#### STATE OF TENNESSEE DEPARTMENT OF TRANSPORTATION

#### **INSTRUCTIONAL BULLETIN NO. 19-18**

#### Regarding Various Revised and New Standard Drawings.

> MARKING DETAIL FOR **EXPRESSWAY** AND **FREEWAYS**

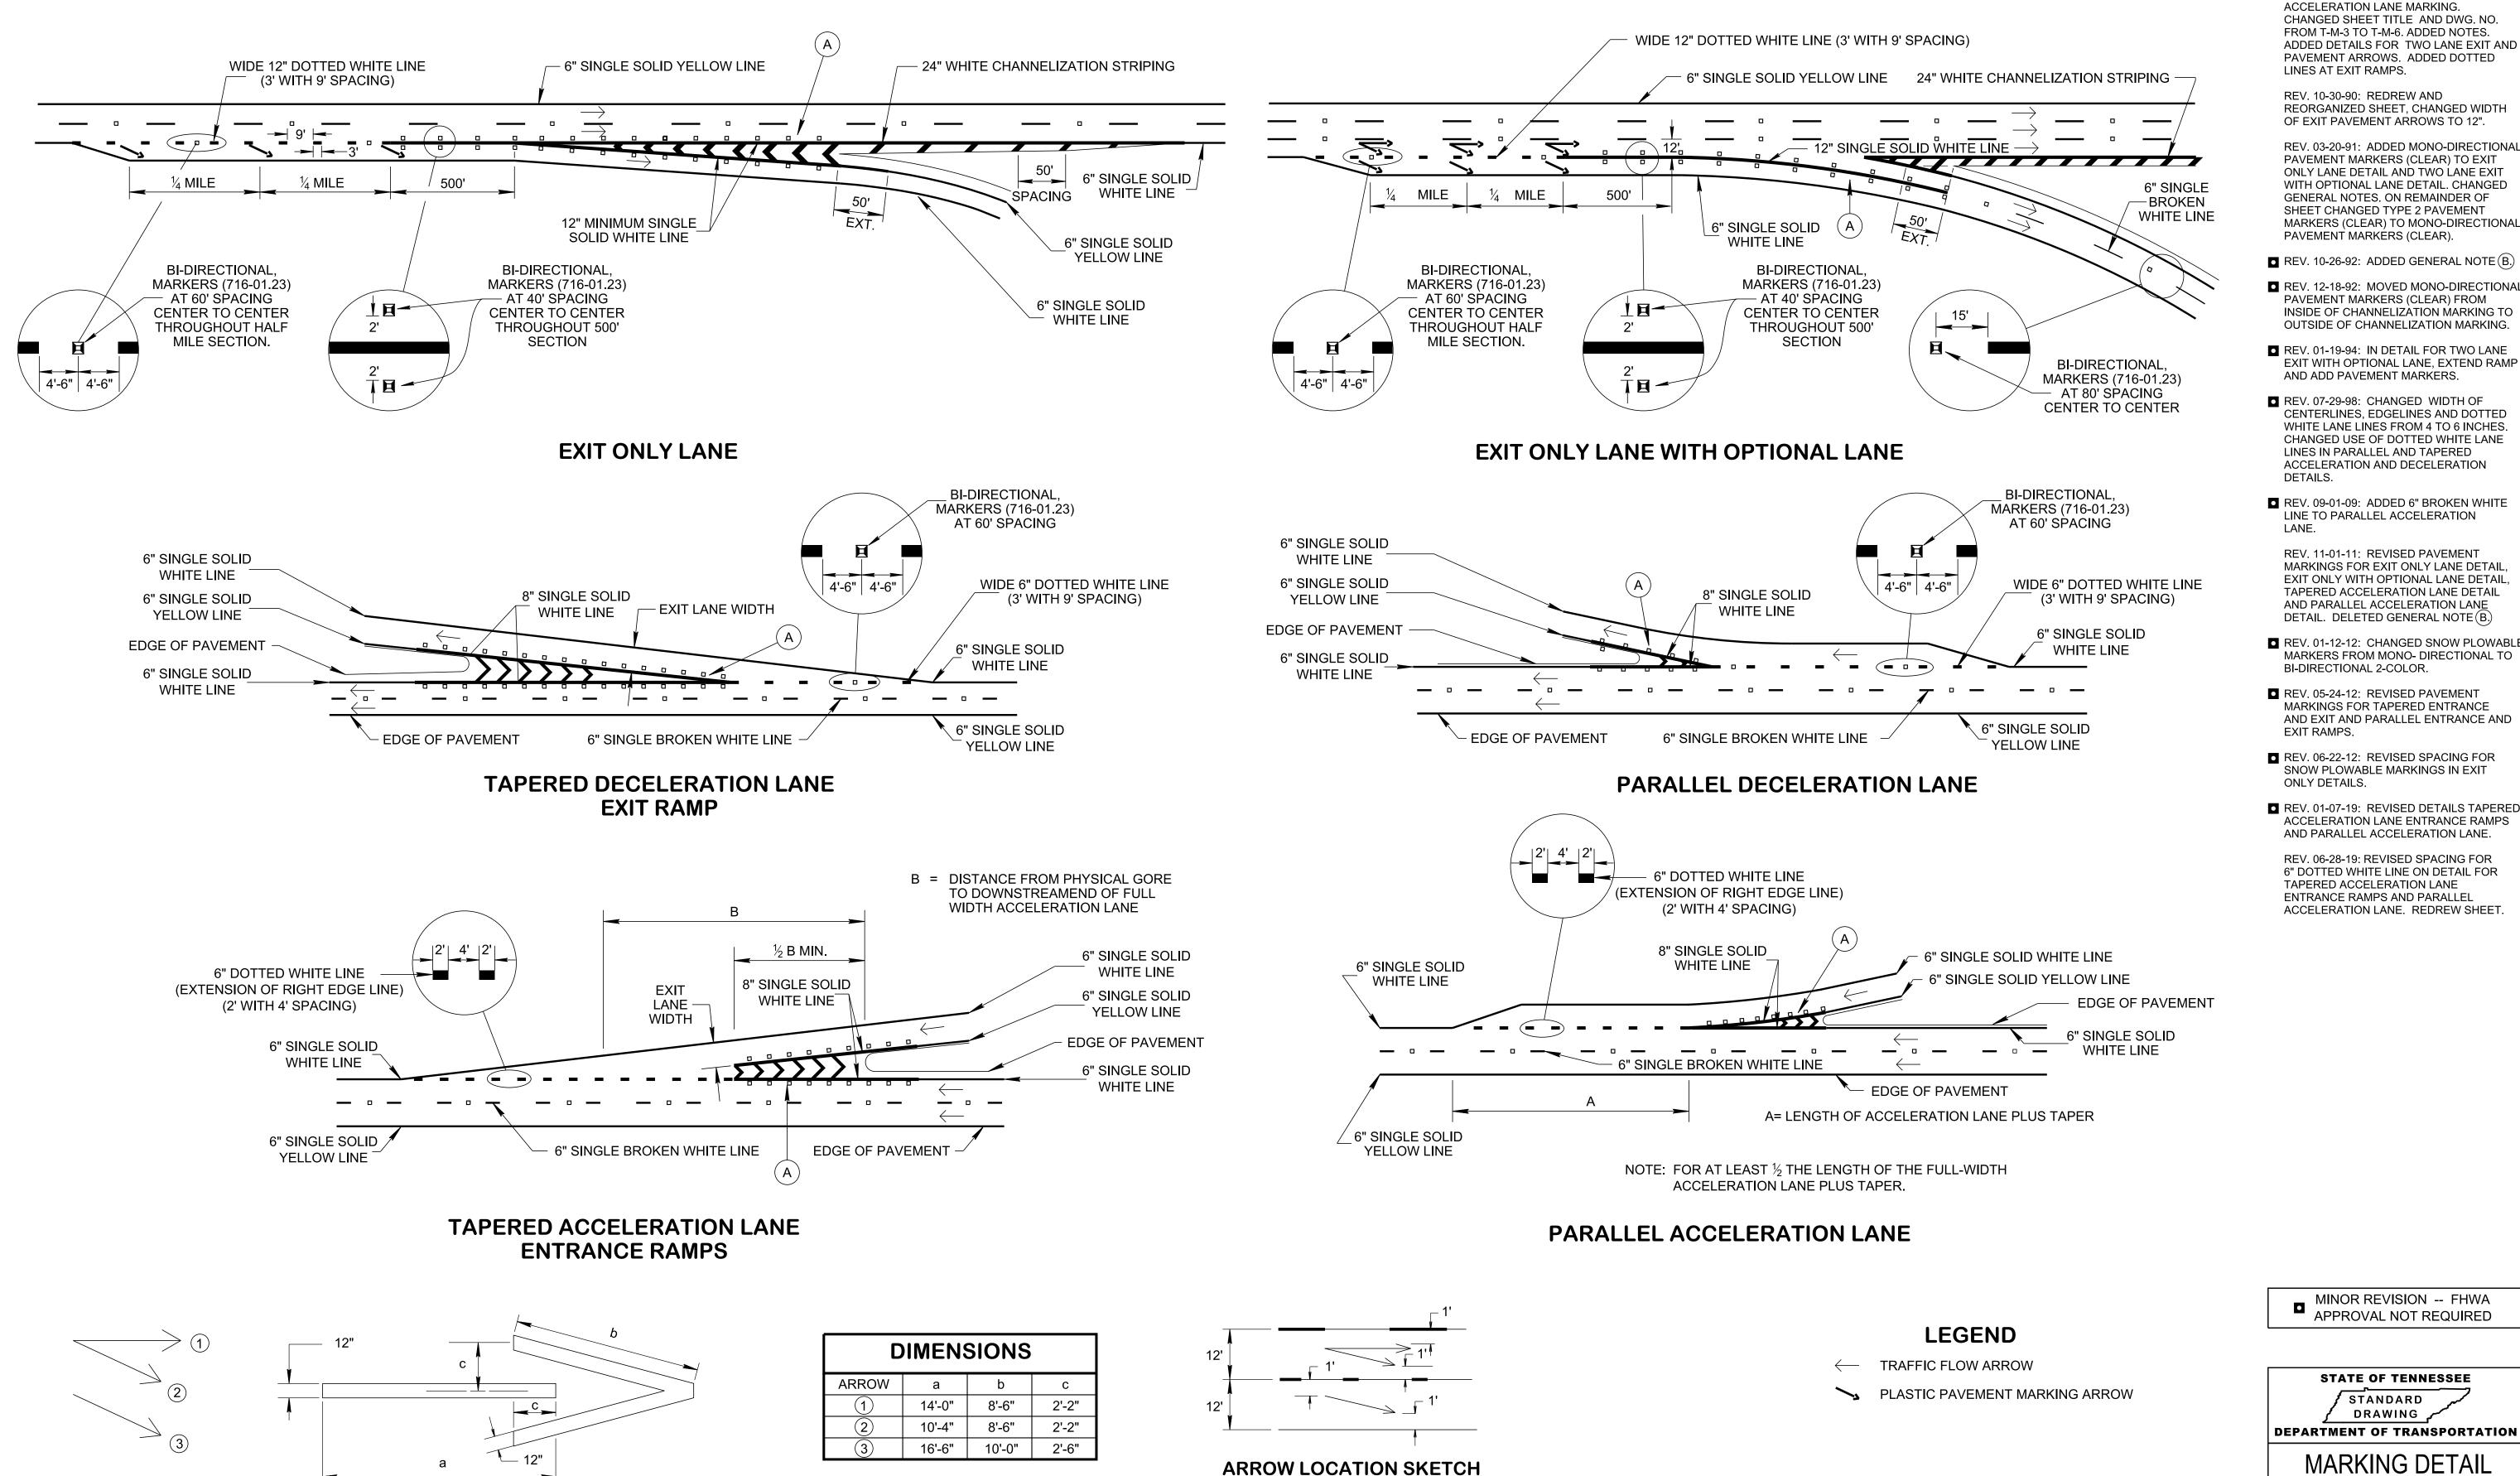
REV. 06-28-19: ADDED PAVEMENT MARKINGS AND ITEM NOS. FOR ENHANCED FLATLINE THERMO PVMT MRKNG (6IN LINE) ITEM NO. 716-12.02 AND ENHANCED FLATLINE THERMO PVMT MRKNG (6 IN DOTTED LINE) ITEM NO. 716-12.05 TO DRAWING. ADDED ITEM NOS. 716-04.09 AND 716-04.14. REDREW SHEET.

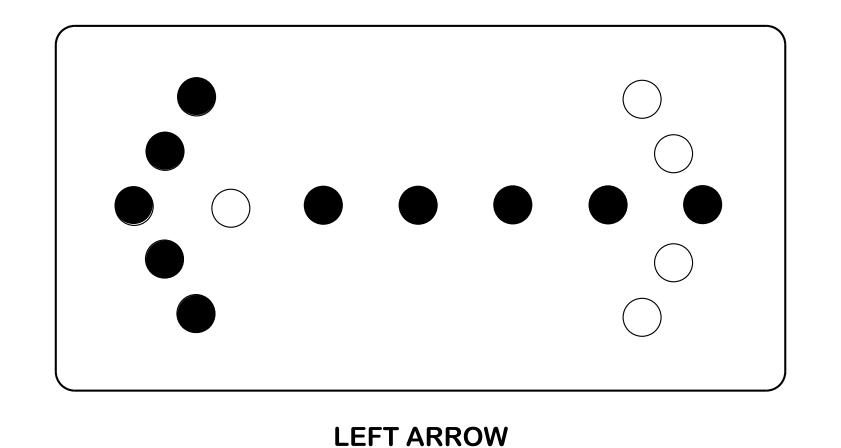
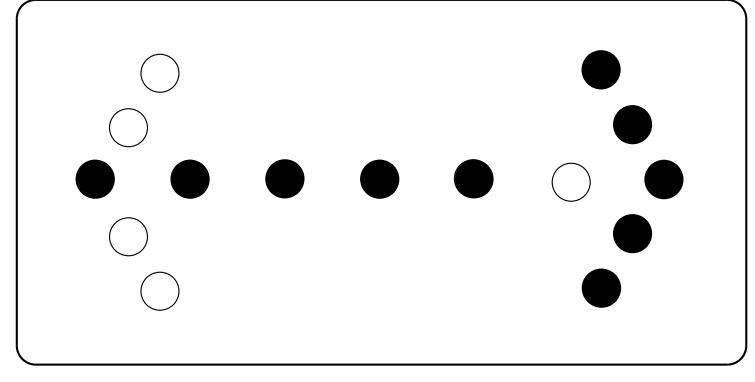
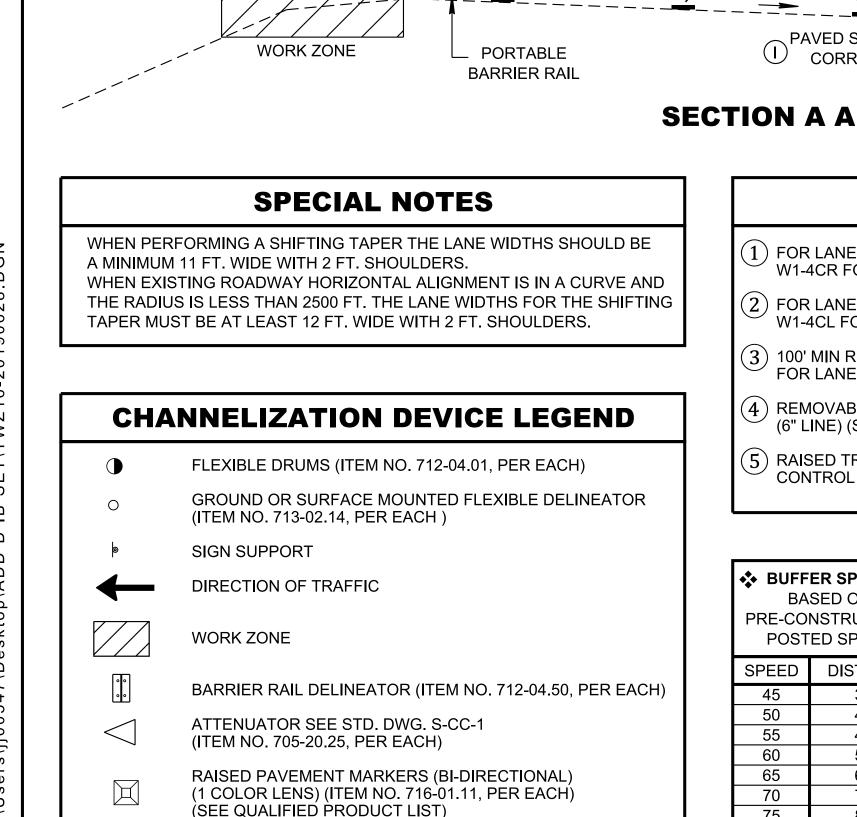
REV. 06-28-19: REVISED ALL NOTES, COMPUTATION FOR DISTANCE L BLOCK. ADDED SECTION A A AND DETAIL A. ADDED SIGNS NOS. W-20-1 & R4-9. RENAMED AND REDREW SHEET.
